<b>Subject:</b>	Improvement of SOT-89B Package
<b>Data Sheet Concerned:</b>	HAL 114, 115, 6251-456-2DS, Dec. 20, 1999 HAL 50x, 51x, 6251-485-1DS, Feb. 16, 1999 HAL 55x, 56x, 6251-425-1DS, April 6, 1999 HAL 621, 629, 6251-504-1DS, Feb. 3, 2000
<b>Supplement:</b>	No. 1/ 6251-531-1DSS
<b>Edition:</b>	July 4, 2000

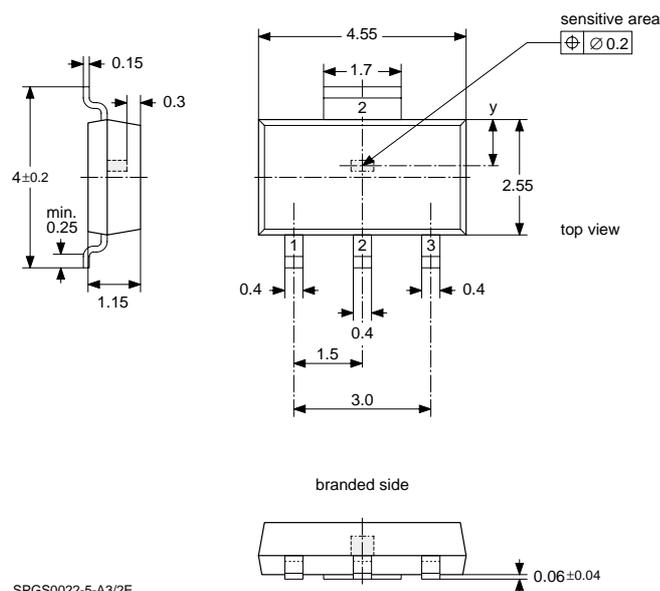
- position tolerance of the sensitive area reduced
- tolerances of the outline dimensions reduced
- thickness of the leadframe changed to 0.15 mm (old 0.125 mm)
- SOT-89A will be discontinued in December 2000

HAL 114, 115 HAL 50x, 51x HAL 621, 629	HAL 55x, HAL 56x
x	center of the package	center of the package
y	0.95 mm nominal	0.85 mm nominal

**Note:** A mechanical tolerance of  $\pm 0.05$  mm applies to all dimensions where no tolerance is explicitly given. Position tolerance of the sensitive area is defined in the package diagram.
